SERVICE LETTER August 11, 2020

Inspection of aileron root rib, left and right wings

The affected models are aircraft CH 2000 serial numbers 20-0002 and up.

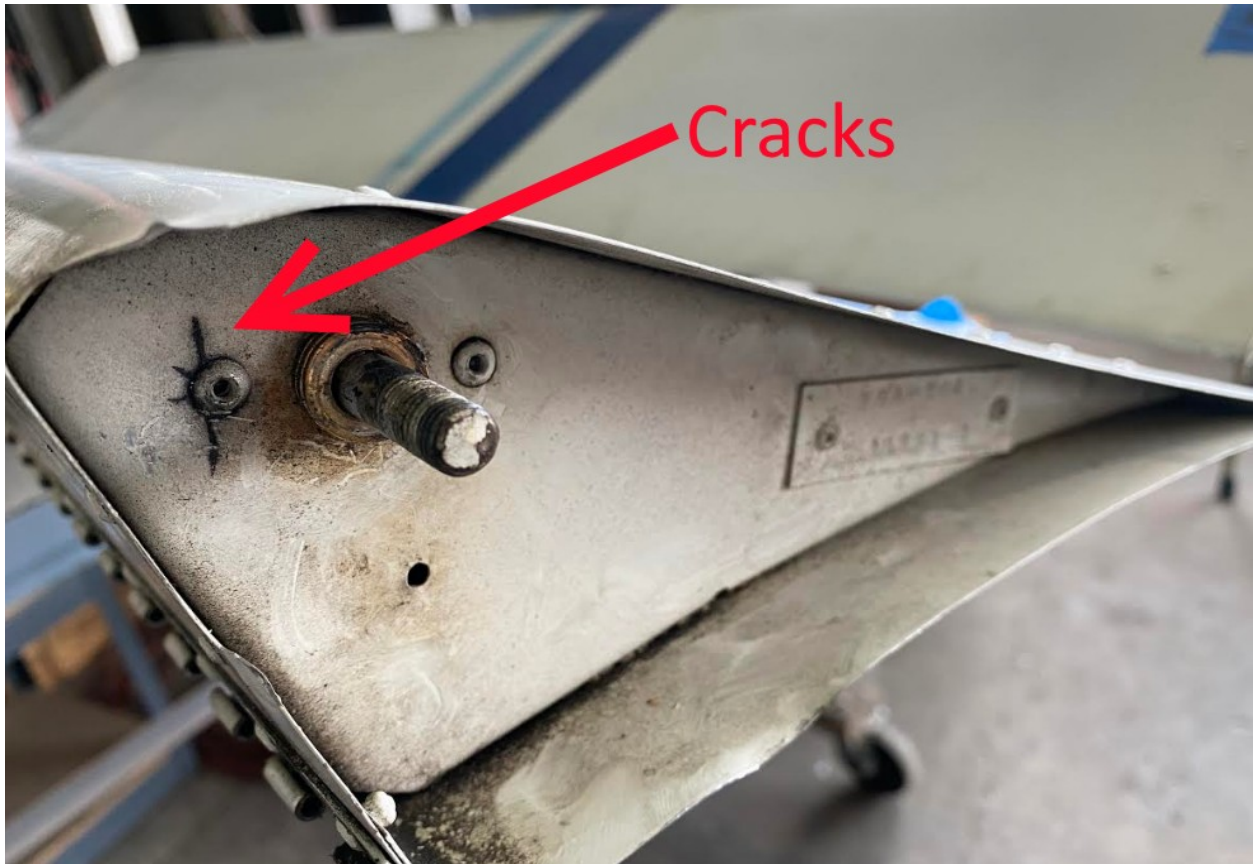
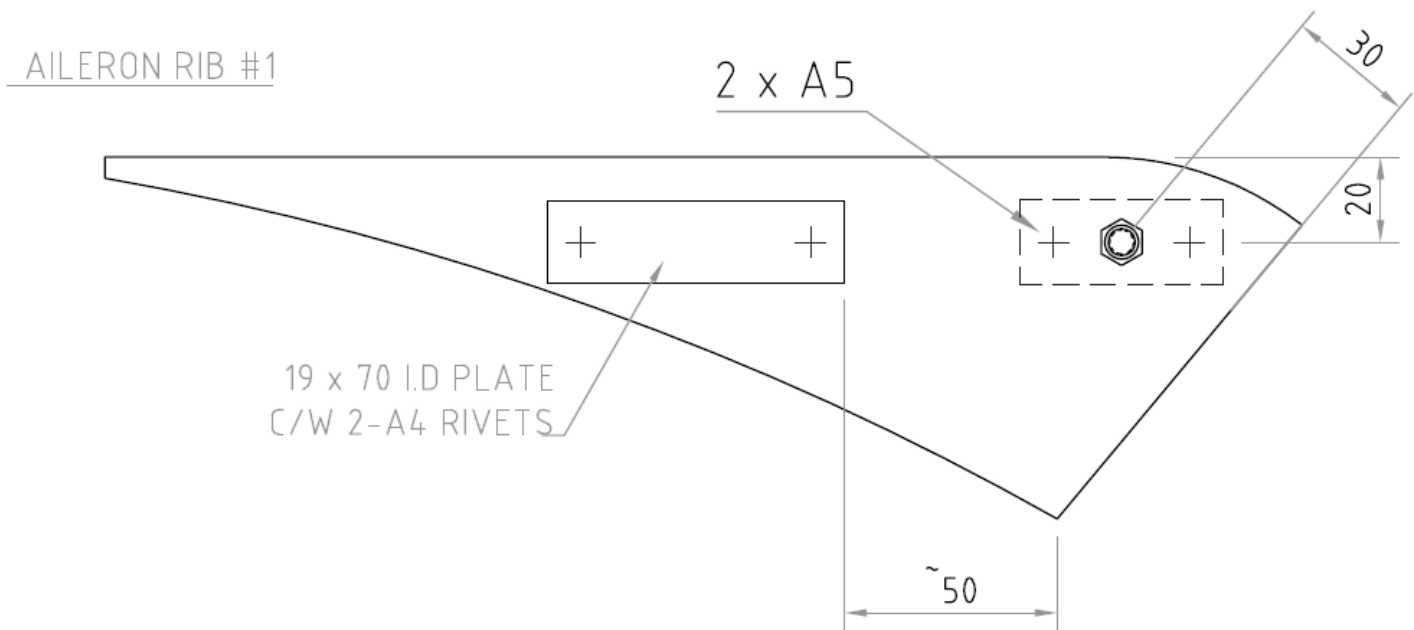
A CH2000 customer noticed cracks in his aileron root ribs as per the following photos.

Confirm that there are no cracks in the aileron root rib or surrounding area. Left and right ailerons.

If cracks are present, remove the root rib and replace Part number 20-A-1-1. Use the cracked rib to copy the pin hole location to the new rib. Use A5 rivets (5/32" dia Zenair rivets) to install. See the Service Manual. Or, fix the existing rib(s). Use AC-43.13-1B page 4-32.

Once completed, perform a full inspection of the aileron system including the cable tensions.
